ISSUED FOR	DATE
ADDENDUM #1	MAY 1, 2020

PROJECT TITLE
KPS ADMINISTRATION BUILDING AV SYSTEMS

SHEET TITLE
MEDIUM & UPPER LEVEL LIGHTING PLAN

SHEET NUMBER
E 201
18-525.00

MEDIUM & UPPER LEVEL LIGHTING PLAN

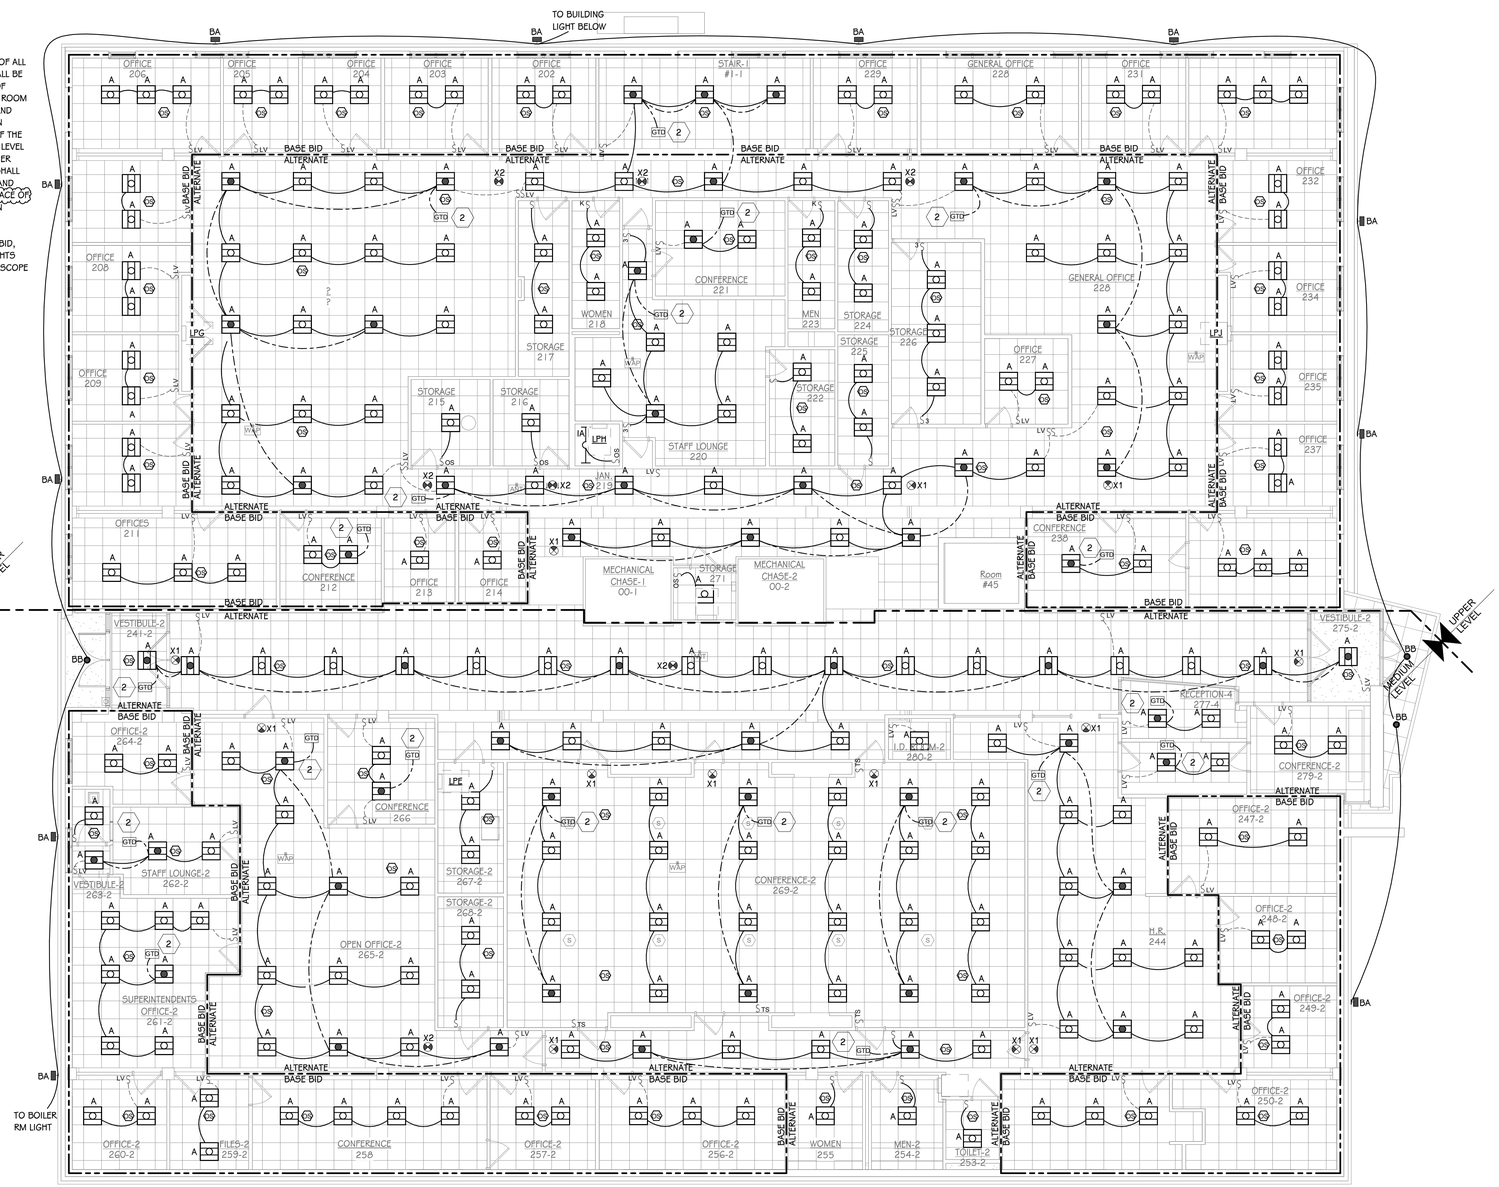
BASE BID – REMOVAL AND REPLACEMENT OF ALL EXTERIOR BUILDING MOUNTED LIGHTS SHALL BE BASE BID. REMOVAL AND REPLACEMENT OF PENTHOUSE AND BASEMENT MECHANICAL ROOM LIGHTING SHALL BE BASE BID. REMOVAL AND REPLACEMENT OF LIGHTING CALLED OUT IN PERIMETER OFFICES AND STAIR ROOMS OF THE LOWER LEVEL, MEDIUM LEVEL, AND UPPER LEVEL SHALL BE INCLUDED IN BASE BID. ALL OTHER LIGHTING, LISTED IN ALTERNATE REGION, SHALL BE TEMPORARILY SUPPORTED, REMOVED AND ~~AND~~REINSTALLED INTO NEW CEILING IN PLACE OF EXISTING. REFER TO SCOPE BOUNDARY ON DRAWINGS.

ALTERNATE NO. 3 - IN ADDITION TO BASE BID, REMOVE AND REPLACE ALL REMAINING LIGHTS NOT CALLED OUT AS BASE BID. REFER TO SCOPE BOUNDARY ON DRAWINGS.
